Appl. No. 10/029,530
Amendment dated May 25, 2004
Reply to Office Action of February 25, 2004

Circuit and Method for Discharging High Voltage Signals

ANNOTATED SHEET SHOWING CHANGES

FIG. 1

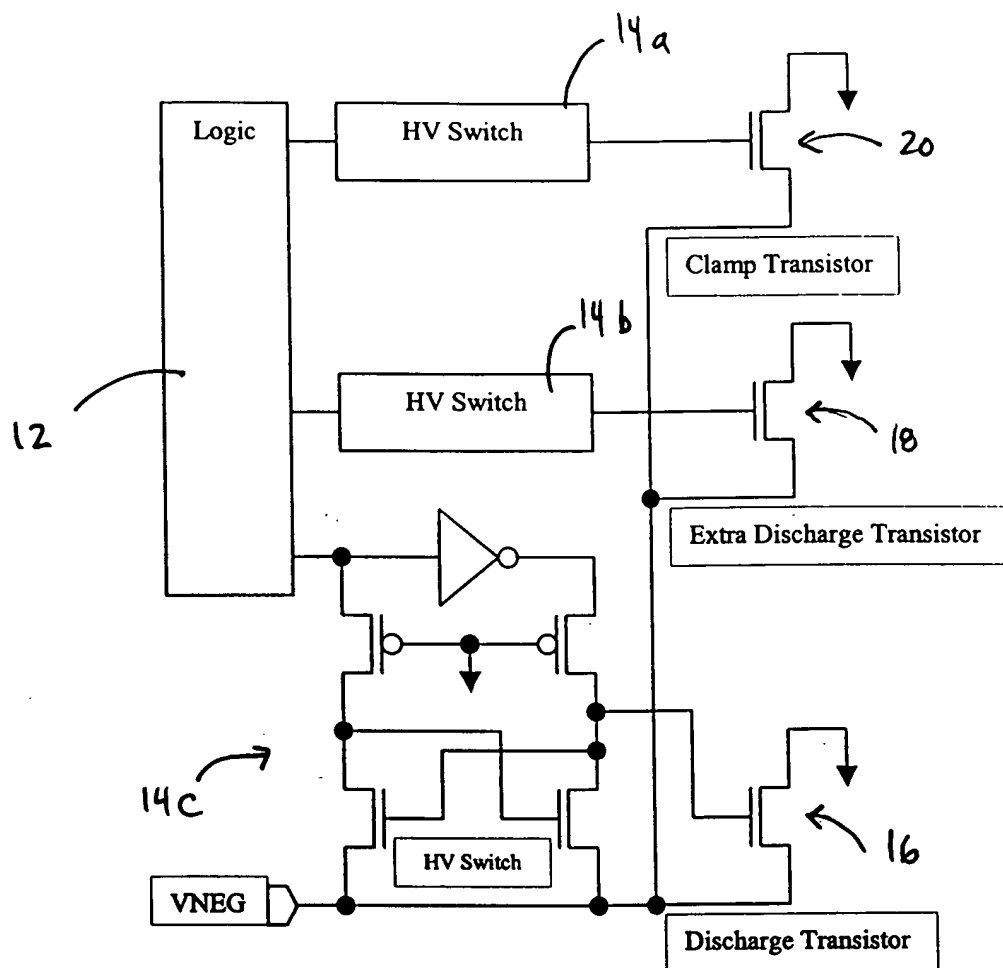
The Examiner indicated his belief that "Fig. 1 should be designed by a legend such as "Prior Art" and requires a proposed drawing correction. Accordingly, Fig. 1 has been amended to include the legend "PRIOR ART" and it is respectfully requested that this objection be withdrawn.

LEGEND
"PRIOR ART"
ADDED
